THE BACK FORTY SUBDIVISION

APPLICATION NUMBER 5 DATE April 20, 2017

DETAIL SITE PLAN

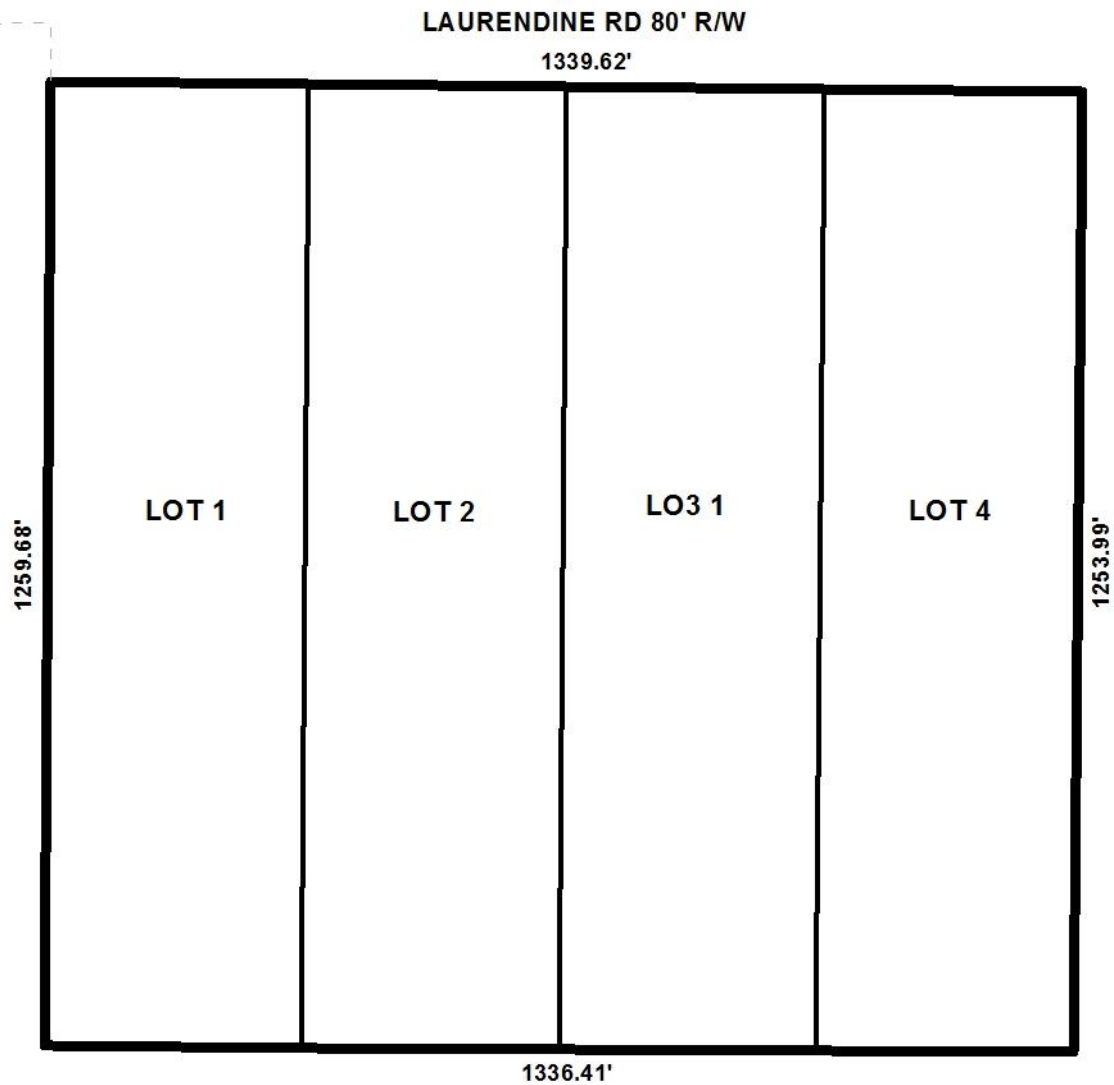
The proposed lot fronts Laurendine Road, a major street per the Major Street Plan. Laurendine Road is depicted as having an 80' right-of-way width on the preliminary plat. As a major street, a minimum 100' right-of-way width is required; therefore 50' dedication from the centerline should be required. If approved, the right-of-way width along Laurendine Road should be revised to provide dedication, on the Final Plat.

The preliminary plat does not illustrate building setback lines. If approved, Final Plat should be revised to illustrate the required 25' minimum building setback line along Laurendine Road.

It should be noted that the proposed lots do not meet the width-to-depth ratio. Section V.D.3. of the Subdivision Regulations states that lot depth should not exceed 3.5 times the width of the lot at the building setback. The proposed Lots 1, 2, 3, and 4 are all at least 334.91'± wide and more than 1,250'± deep, resulting in lots that are deeper than would normally be allowed (a ratio of 3.7). As there are similarly configured lots in the vicinity, a waiver of Section V.D.3. of the Subdivision Regulations may be appropriate.

As a means of access management, a note should be placed on the Final Plat, if approved, stating that each proposed lot is limited to two curbs cut to Laurendine Road, with the size, design and

location of the curb cut to be approved by Mobile County Engineering and conform to AASHTO standards.

- 1) Dedication to provide 50' from the centerline of Laurendine Road;
- 2) Provision of 25' minimum building setback line along Laurendine Road;
- 3) Retention of the lot size information in both square and in acres on the Final Plat, adjusted for dedication;

- 4) Placement of a note on the Final Plat stating that each proposed lot is limited to two curb cuts along Laurendine Road, with the size, design and location of the curb-cut to be approved by Mobile County Engineering and conform to AASHTO standards;
